**Baw Baw Planning Scheme Amendment C145bawb
Permit PLA026/21 to the Baw Baw Planning Scheme
Yarragon expansion**

Panel Report

24 January 2023

Figure 5 1 per cent AEP Flood Map – Change in flood depth

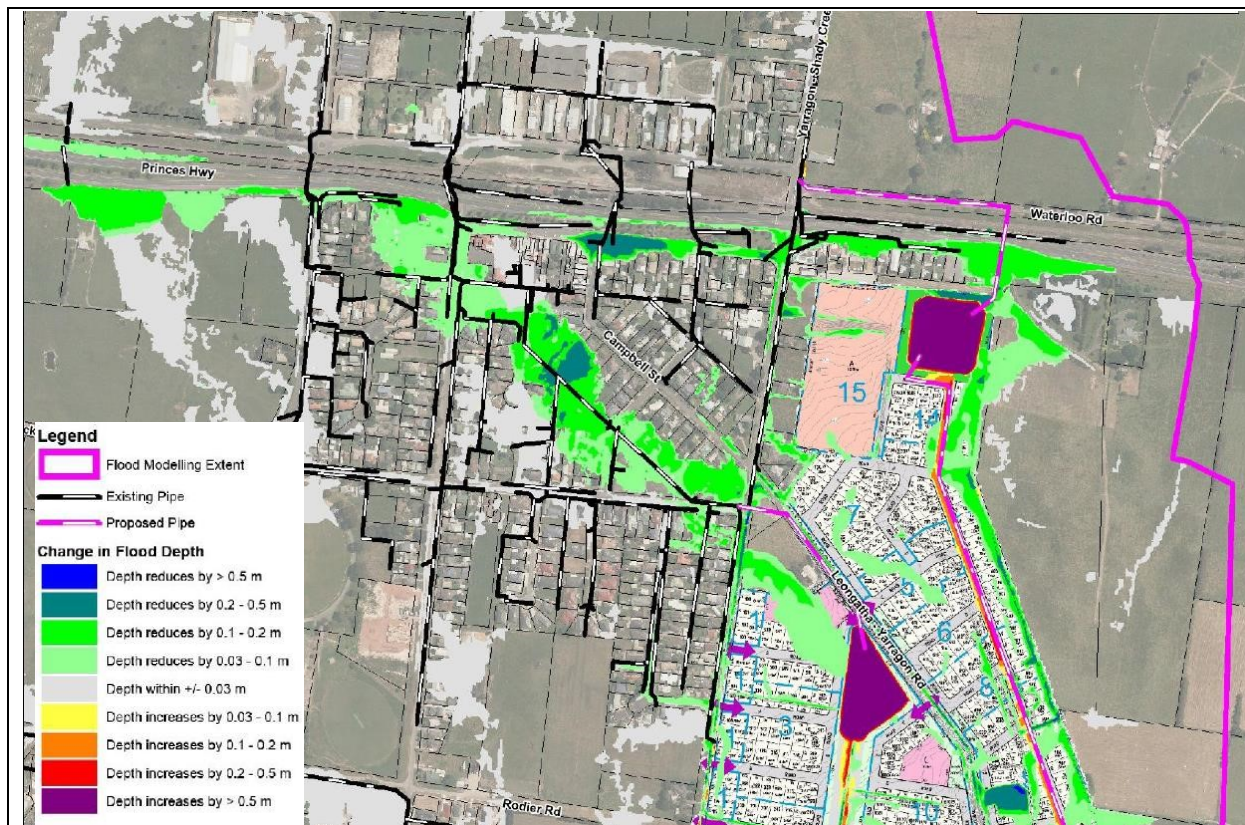
Mr Greg Dyer submitted that based on his analysis, the exiting Yarragon pipe drainage system is currently under capacity for a 1 in 5 years rainfall event and the main restriction is the pipe culverts under the railway line. He submitted that no further stormwater should be added to the existing drainage system and all stormwater from the proposed development should be directed around the town to the east of the service station on the Princes Highway. He believed that the Engeny analysis which depicts the level of flooding between Market and Campbell Streets diminishing after development of the site to be erroneous because the development will put more water into the existing drainage system than is currently the case.

He noted that approval from the relevant authorities to construct a new culvert under Princes Street and the railway line as proposed by the developer had not been established and the developer should show proof of permission to construct a new culvert which is essential to any development of the subject land.

The Proponent submitted that the updated flood modelling done by Engeny which included the subject site "*under development conditions*" demonstrated an approximately 60 per cent reduction in flooding within the existing township (see Figure 5 below). Millar Merrigan noted additional redundancy was added to the drainage system with the incorporation of an additional outlet across the Princes Highway/VicTrack rail reserve.

On the expert evidence before it, the Panel is satisfied that the proposed stormwater infrastructure plan will manage to an appropriate level the flooding risks to the development and, most importantly, will ensure that the development does not exacerbate the risk of flooding of the existing Yarragon township. The Engeny flood modelling (see Figure 5 above) indicates that there will be no increase in flood depth in any part of the existing township under a 1 per cent AEP flood event.

- the proposed stormwater management plan for the development is fit for purpose and will effectively manage the flood risk to the subject land
- the stormwater infrastructure proposed to be constructed as part of the development of the subject site will reduce the flooding impacts on the existing Yarragon township.

Figure 6 General location of specific movement network issues

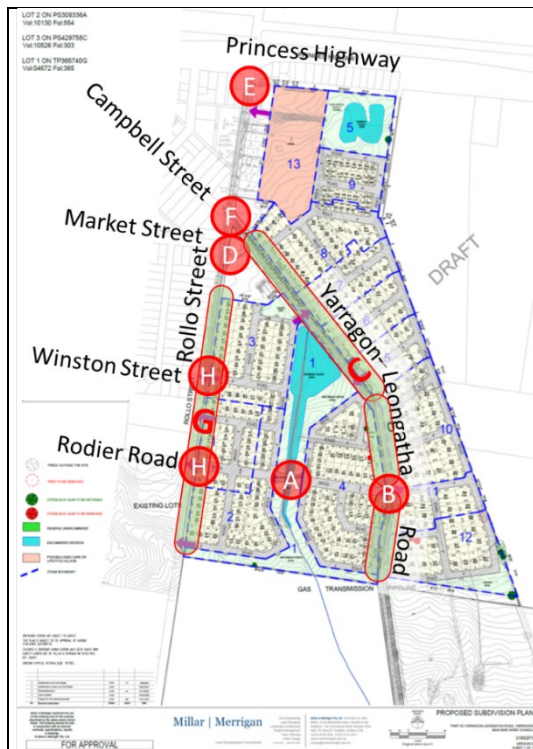
- general issues being whether:
 - the traffic generated by the proposed development can be accommodated on the local road network
 - the subdivision street layout is appropriate
- the need for a 'Traffic Management Plan'
- specific design and cost apportionment issues broadly identified in Figure 6:
 - issue A: East-west road connection
 - issue B: Yarragon-Leongatha Road intersections
 - issue C: Yarragon-Leongatha Road upgrade
 - issue D: Future direct extension of Market Street
 - issue E: Princess Highway intersection
 - issue F: Rollo Street/Campbell Street/Yarragon–Leongatha Road intersection
 - issue G: Rollo Street civil works
 - issue H: Rollo Street intersections.

Council submitted that with the Version 5 subdivision plans which propose a number of cross intersections along Yarragon–Leongatha Road, rather than 'T' intersections as originally proposed, additional roundabouts are required for a number of intersections. The permit conditions reflect this.

The Proponent opposed Condition 36 and wanted the conditions to refer to the works the proposed in the Traffic Management Plan it proposed.

The Proponent opposed Condition 37 seeking that the upgrade of the existing road be limited to upgrades to road surface for only the part of Yarragon–Leongatha Road, running the length and immediately abutting the subdivision area, in the Traffic Management Plan be constructed.

- traffic generated by the proposed development can be accommodated on the existing surrounding road network particularly give the permit requirement for an upgrade to the signalised intersection of Rollo Street and the Princes Highway
- the road layout shown in the amended subdivision plans Version 5 is appropriate

- the inclusion of a condition for a consolidated Traffic Management Plan is appropriate
- determining the treatments for the intersections along Yarragon–Leongatha Road as part of a traffic assessment/functional layout design process will provide appropriate flexibility as the development proceeds

- the planning permit condition requiring the Proponent to fully fund a roundabout or other agreed treatment at the Rollo Street/Campbell Street/Yarragon–Leongatha Road intersection should be deleted

- Rollo Street civil works should be confined the frontage of the development site
- determining the treatments for the intersections along Rollo Street as part of a traffic assessment/functional layout design process will provide appropriate flexibility as the development proceeds.
